To: Ken Roberts, City of Lake Elmo Planning Director
From: Lucius Jonett, Wenck Landscape Architect
Date: October 30, 2019
Subject: City of Lake Elmo Landscape Plan Review
Inwood 7th Addition, Review #1

SITE LANDSCAPE PLAN

INWOOD 7TH ADDITION
5th Street N. & Island Trail
Lake Elmo, Minnesota

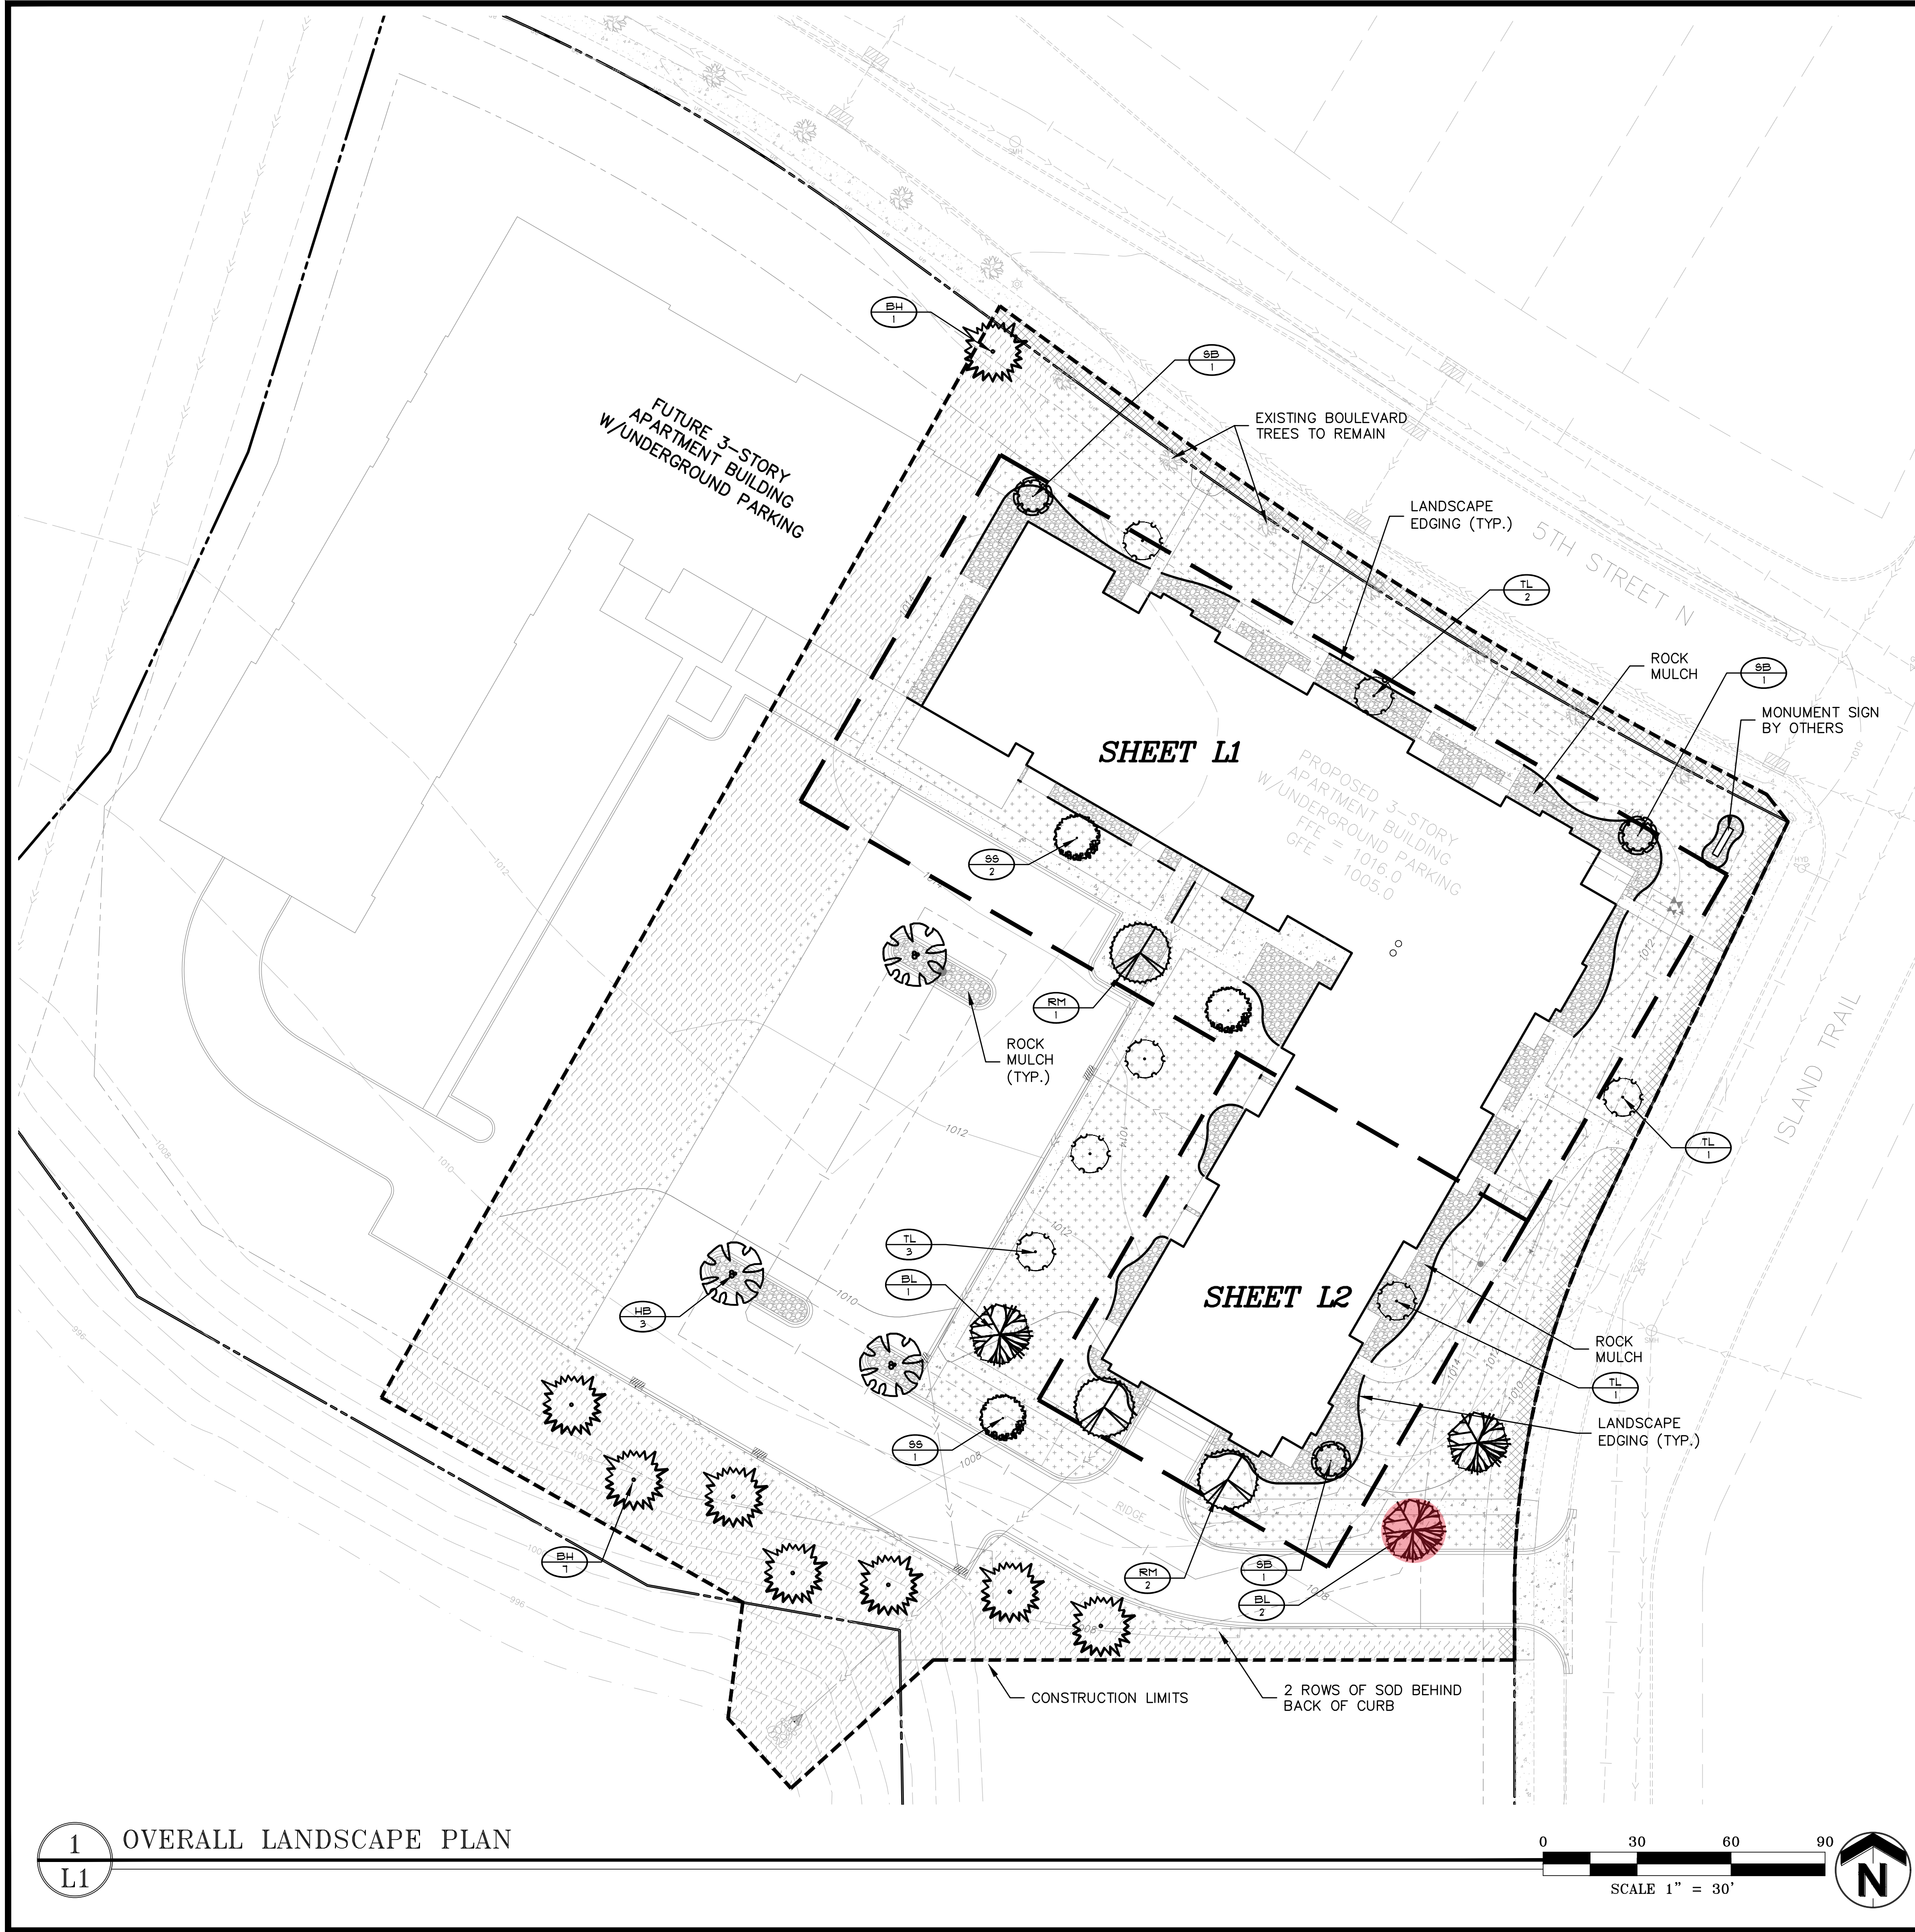
The master plan landscape plans **do not** meet the code required number of trees.

The landscape plans **do not** meet the minimum compositions of required trees:

B. The landscape plan **does not include** the landscape layout requirements:

- Tree Spacing Not Specified
- *No driveway conflicts; Prefer that the trunk of trees shall be 8-10 feet minimum from the nearest driveway edge.*

1. Not all code required trees have been provided.
2. Landscape plans do not meet the minimum composition requirements.
 - a. Too many ornamental species have been proposed. Some of the ornamental species should be exchanged for deciduous or evergreen species as they fit site conditions and to meet the minimum composition requirements.
3. Landscape plans do not meet the landscape layout requirements.
 - a. The Boulevard Linden proposed by the entrance drive is located too close to the driveway edge. See attached figure.
 - b. Only two (2) trees are proposed along Island Trail (measured at approximately 270 lineal feet of frontage) and does not fulfill street frontage requirements of one tree every 50 feet. Provide additional trees along Island Trail street frontage to make the streetscape cohesive with the rest of the Inwood development along Island Trail.

1. Submit a revised landscape plan addressing the above findings.
